CHINO BASIN WATERMASTER

Ground-Level Monitoring Committee

SUBJECT: *1D Model Simulation of Subsidence in Northwest MZ-1—Subsidence Management Alternative #1 (FINAL)*

APPENDIX A – RESPONSES TO GLMC COMMENTS24

Figure 2. PX Site: CVM Layers, Borehole Lithology, 1D Model Cells, and Resistivity Log

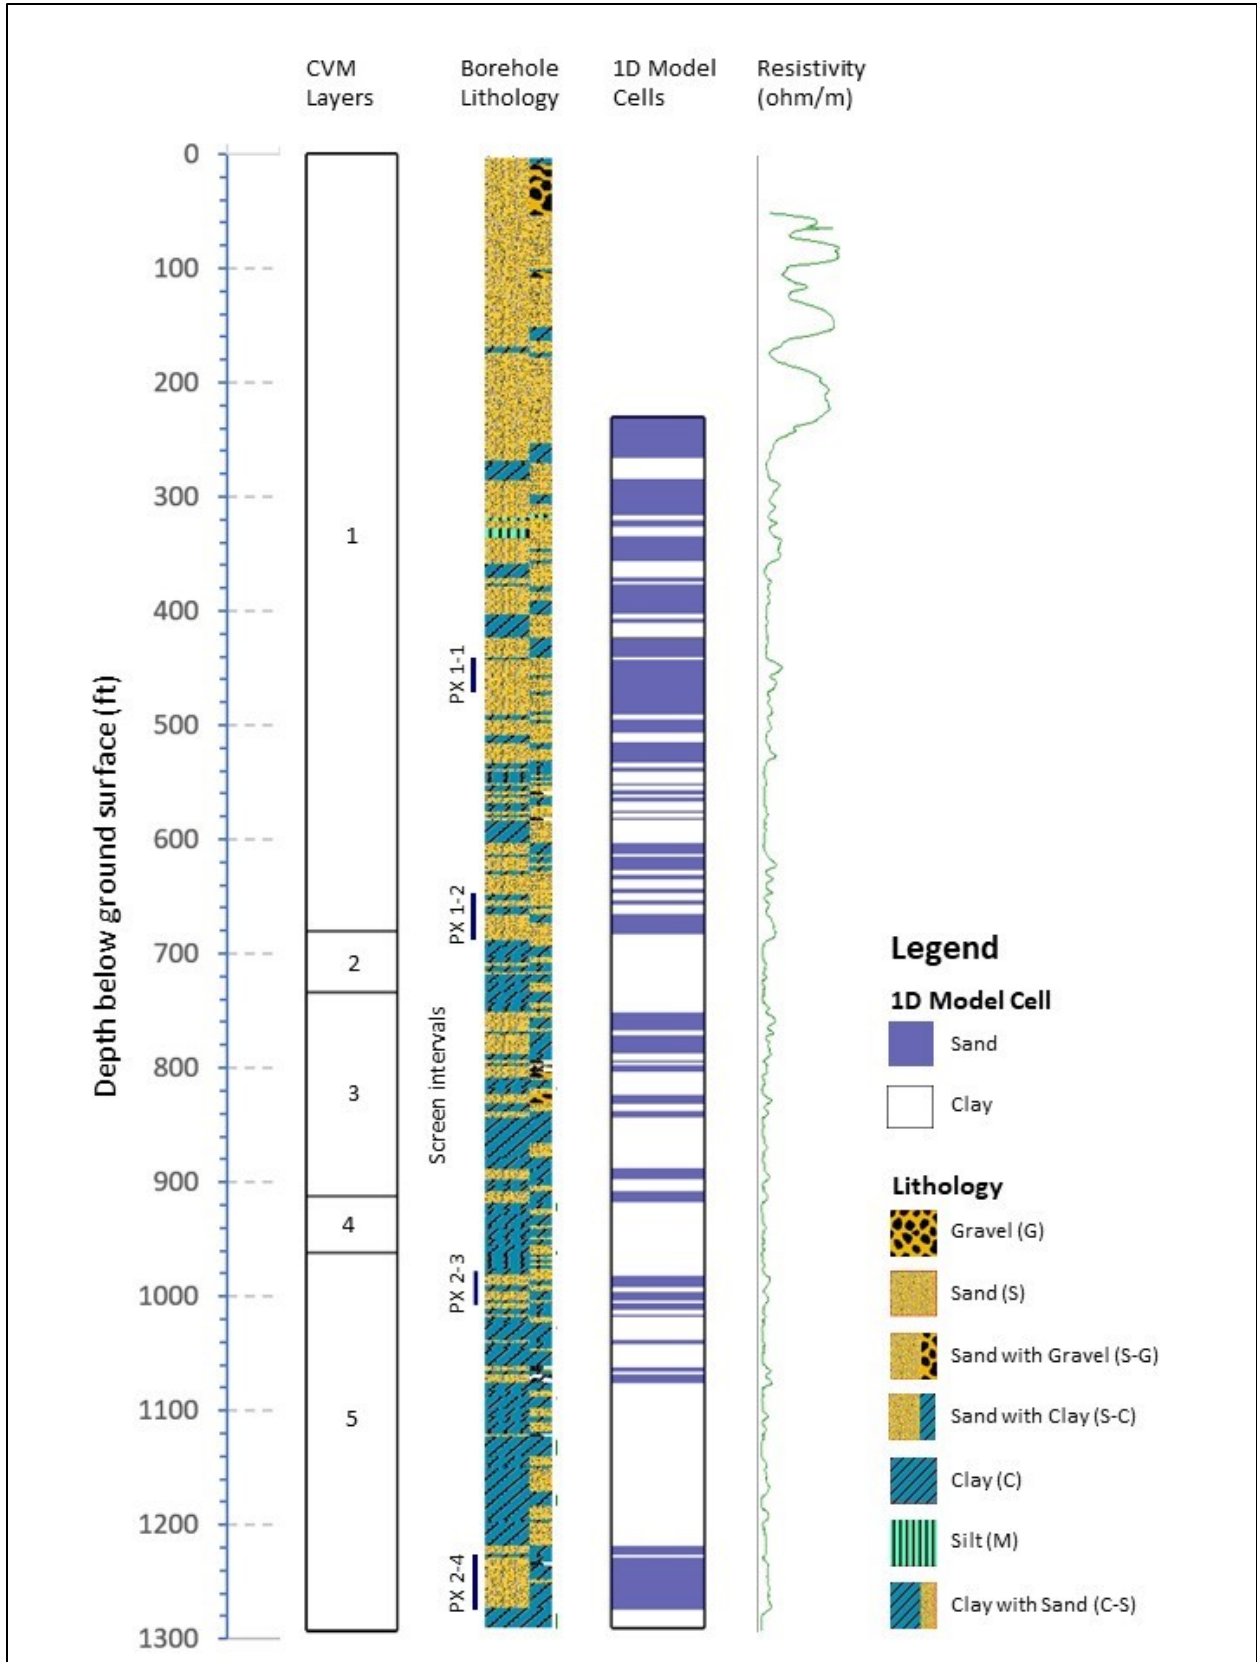
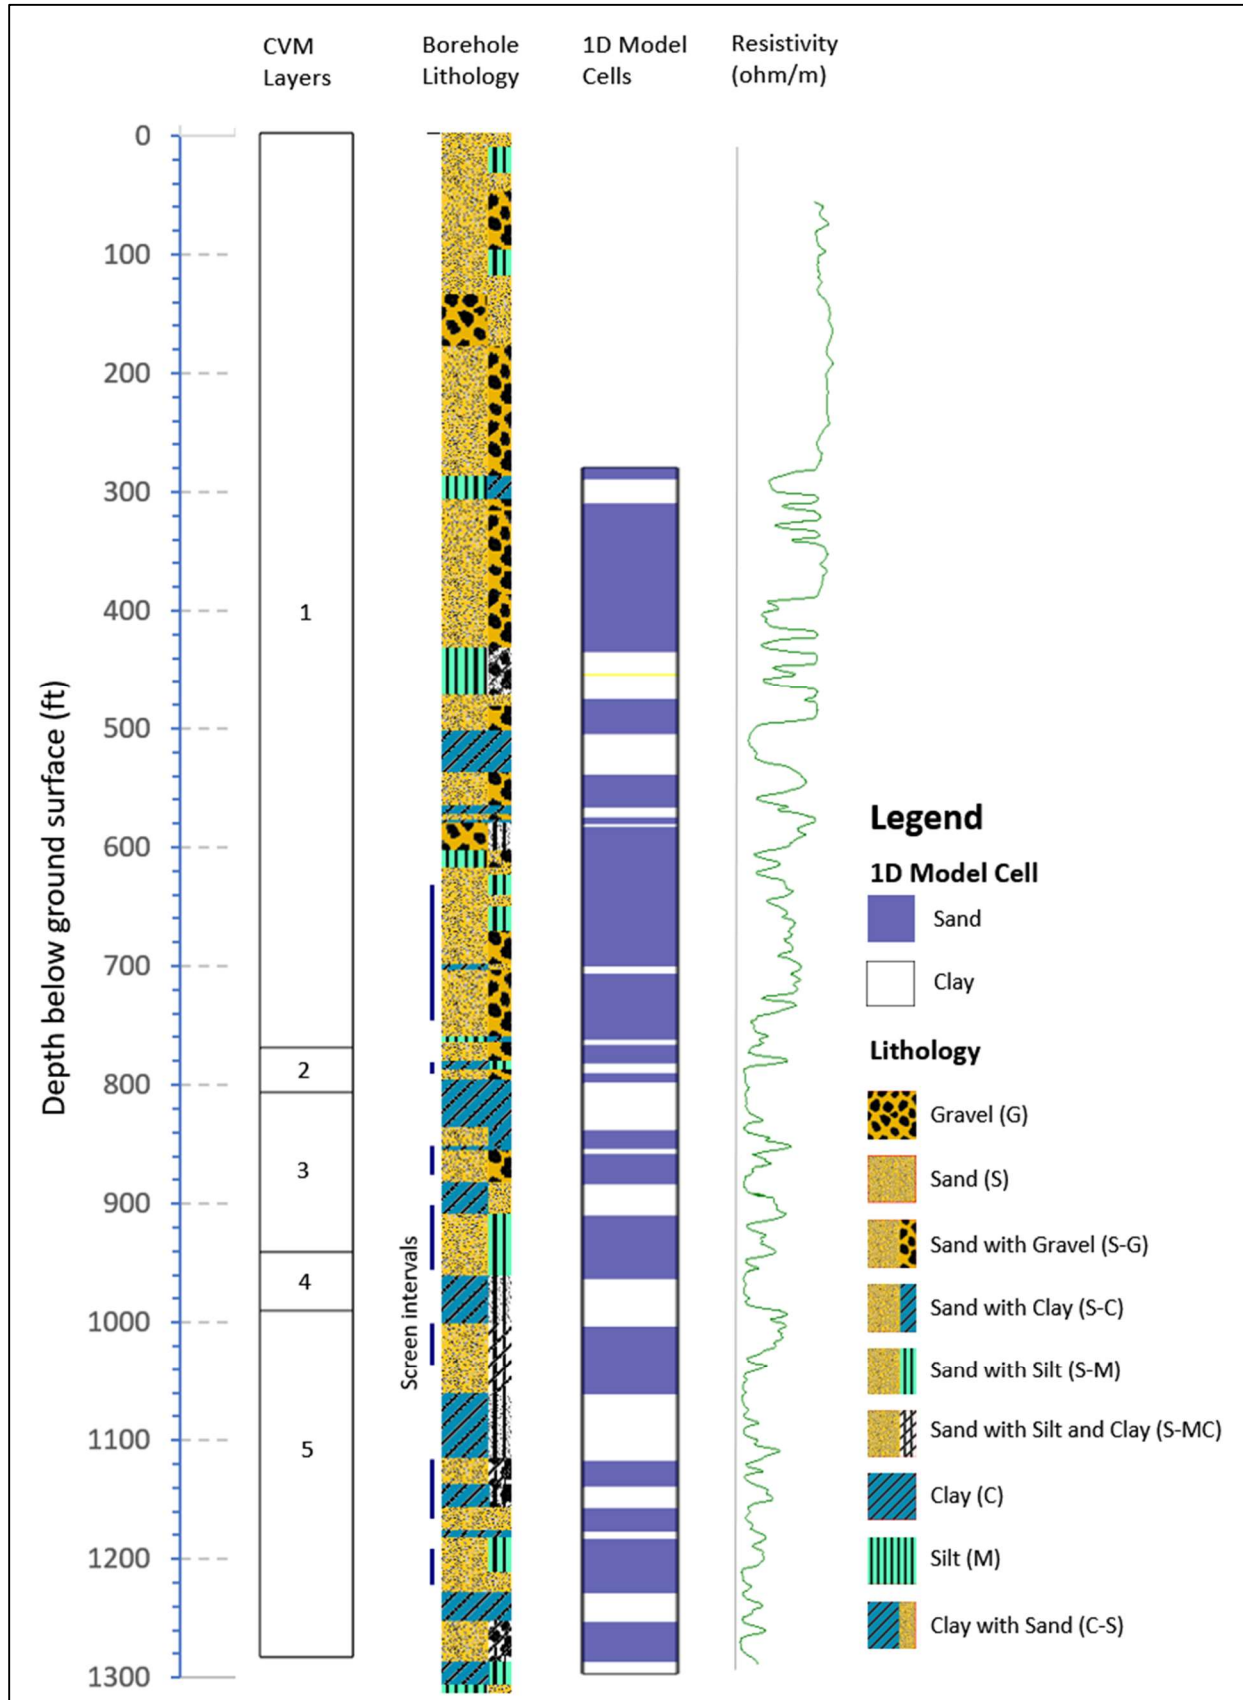
Comment 13 – Figures 2 and 3

Response:

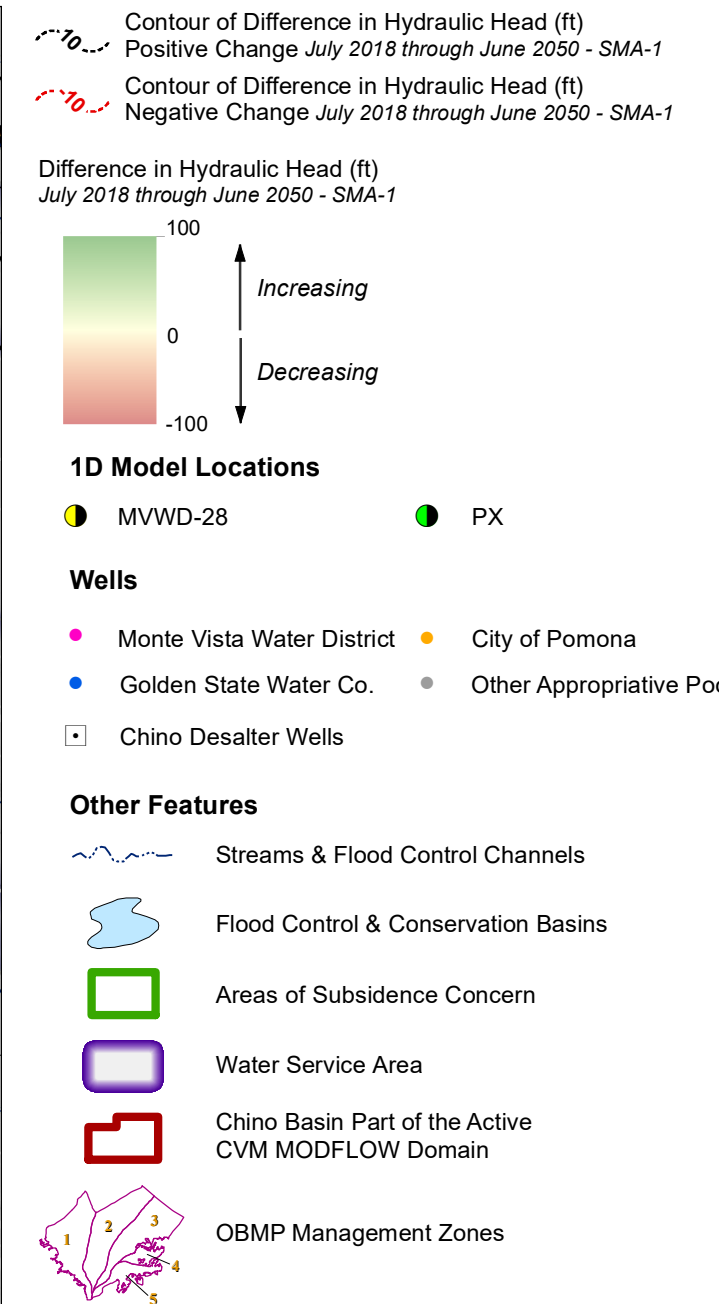
Comment 2 – Figure 5

Figure 5 – contours of the negative differences in hydraulic heads south-southeast of the Central MZ-1 are odd, with the negative 10-foot and negative 20-foot contours overlapping. Please verify that this is correctly contoured.

Response:

The figure is correctly contoured. The overlapping and terminal contours are an artifact of the Riley Barrier, which is a groundwater barrier within the deep aquifer system that causes abrupt offsets in hydraulic head.

Figure 11. Projected Heads and Modeled Compaction at the PX Site under SMA-1 (2018-2050)

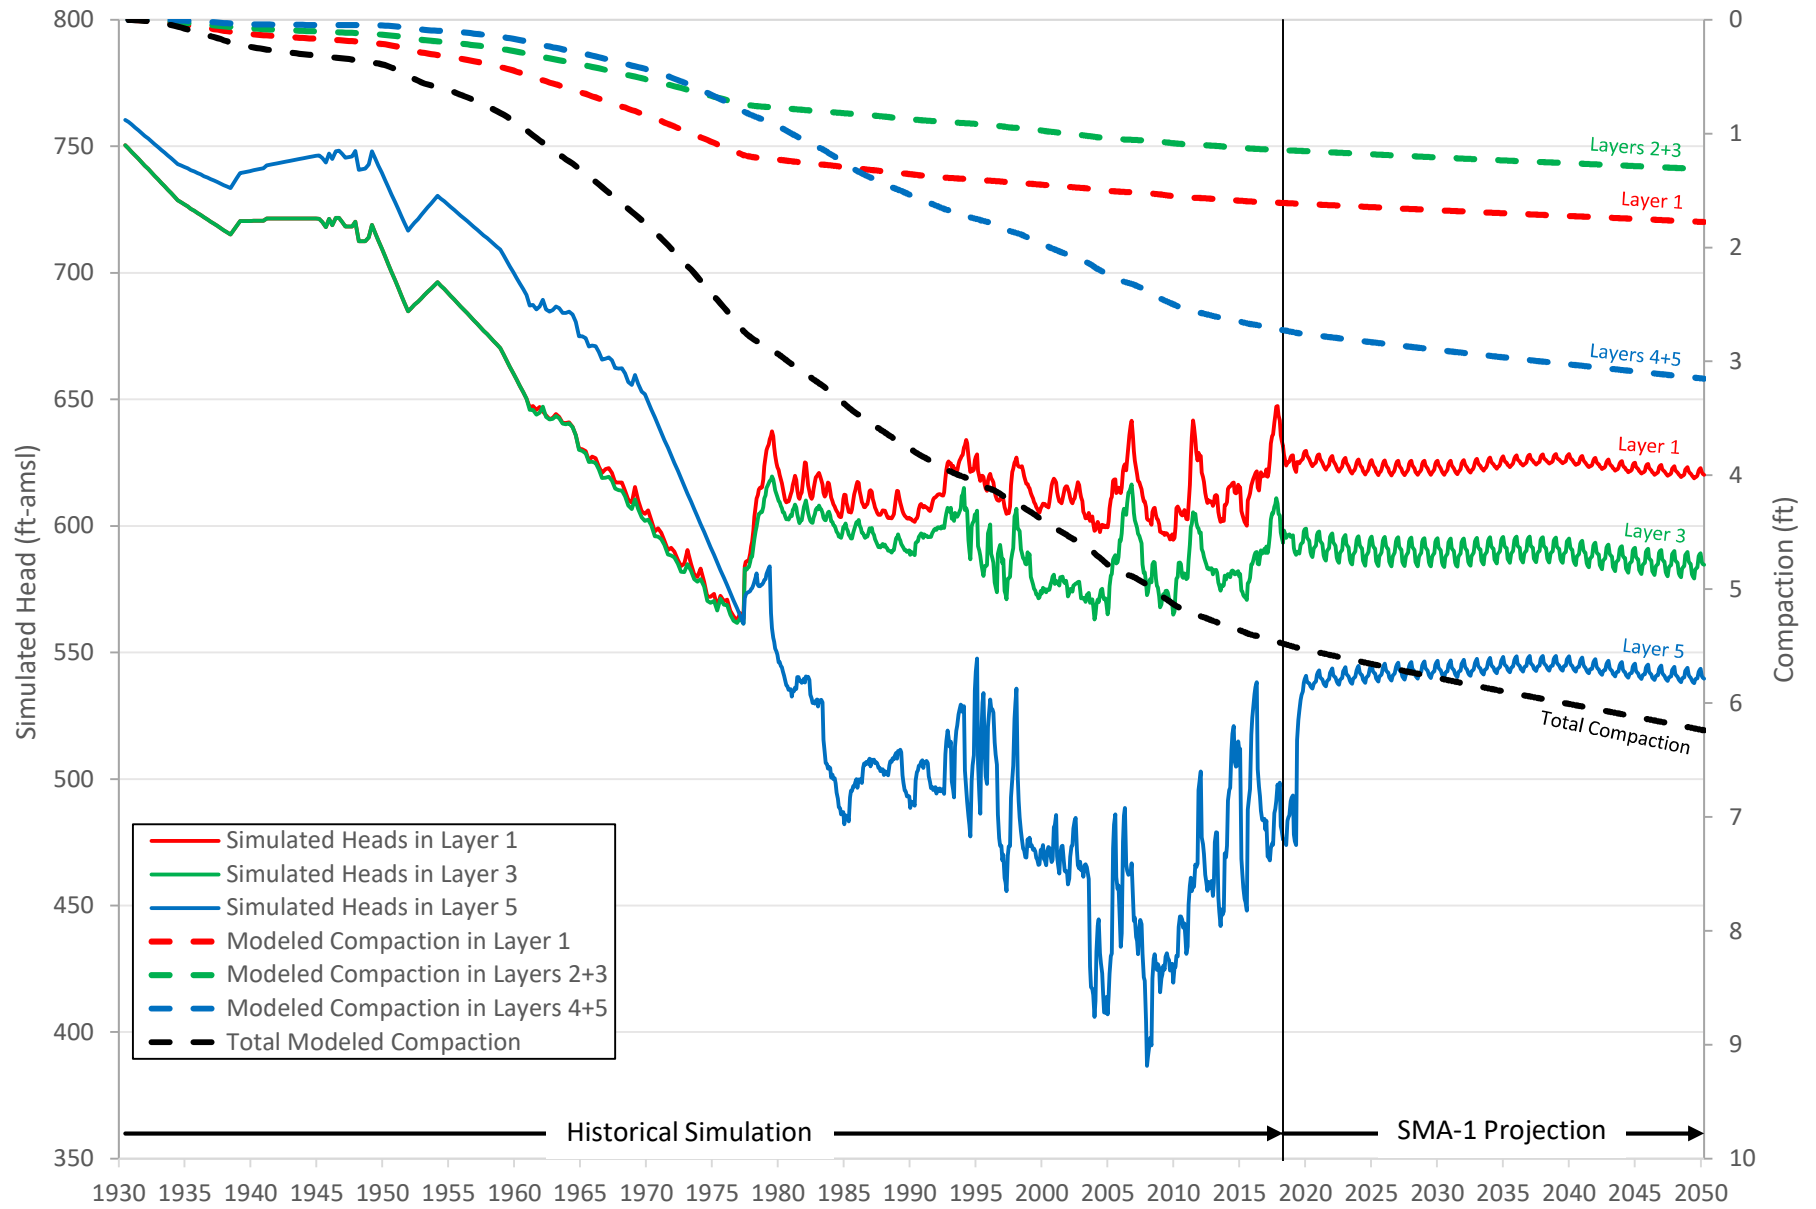
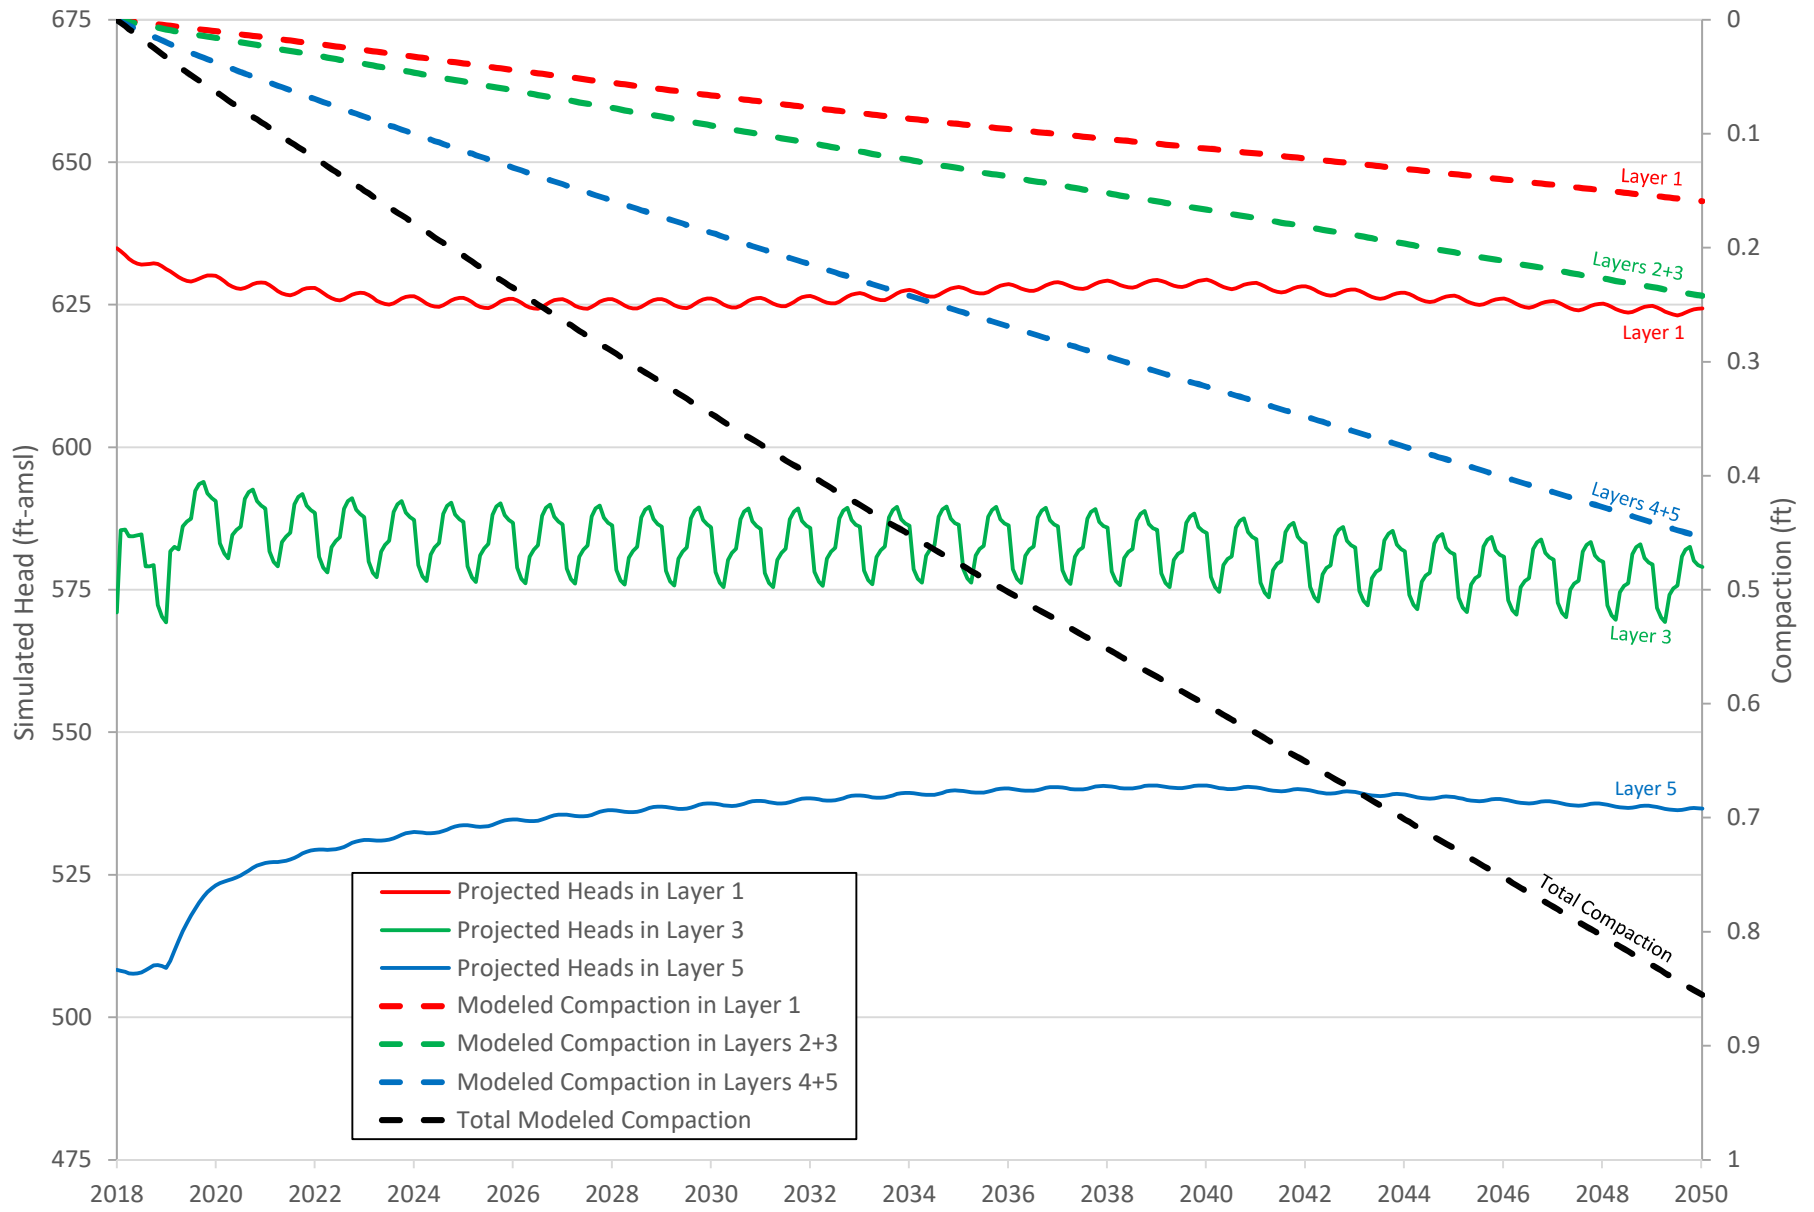
Comment 14 – Figures 11 and 12

Response:

This observation has not been investigated in detail. During 1D Model calibration, there was a significant difference between total simulated compaction from 1930-2018 at the PX (about 9 ft) compared to total simulated compaction at MVWD-28 (about 6 ft).

The observation that projected compaction from 2019-2040 is similar between the two 1D Models, suggests that the delayed drainage and compaction of aquitards is occurring preferentially in various thicker aquitards at each location. However, no analyses have been performed to verify this hypothesis. This is a potential subject of future study and possible incorporation into the 1D Models and/or Guidance Level.
